10/573,671

David John Hill

NON-FINAL OFFICE ACTION

Claims 1-10, 15, and 16 are rejected under 35 U.S.C. 102(b) as being clearly anticipated by Knudsen et al (USPAT 6,575,033).

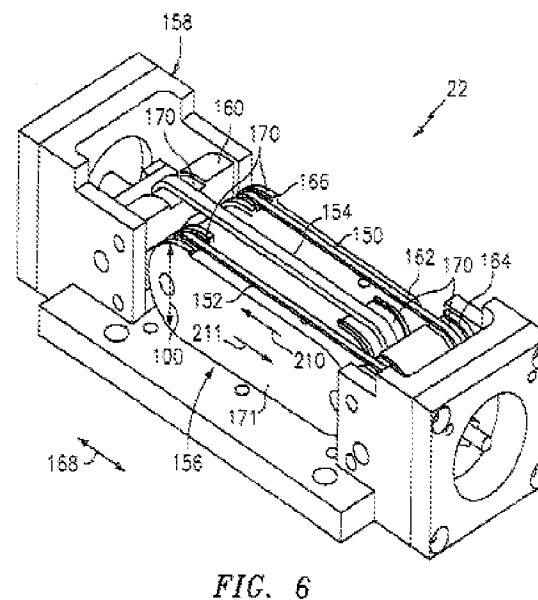
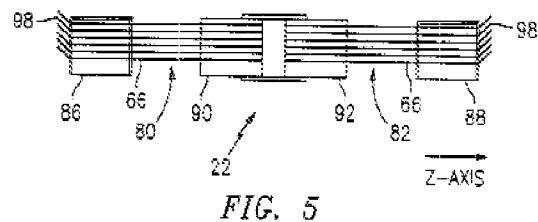
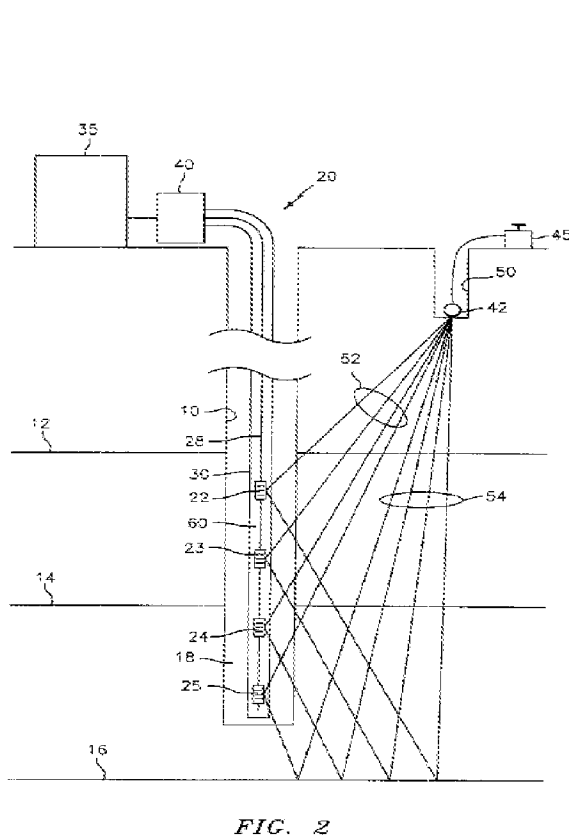
at least two fiber-optic point sensors **22, 24** in fig. 2; and

Distributed fiber-optic sensor (see the optical fiber package including fiber **66** of sensor **23** which is , the detail is shown in fig. 5 and 6) linking said at least two fiber-optic point sensors **22, 24**, wherein said sensor array provides an array output of sensed data from said at least two fiber-optic point sensors and said distributed fiber-optic sensor (see that the existence of the signal converter **40** and signal processing equipment **55** reflects that the sensor array provides array output of sensed data).

In re claim 5, fig. 5 and 6 shows that the optical fiber wound into a flexural disc.
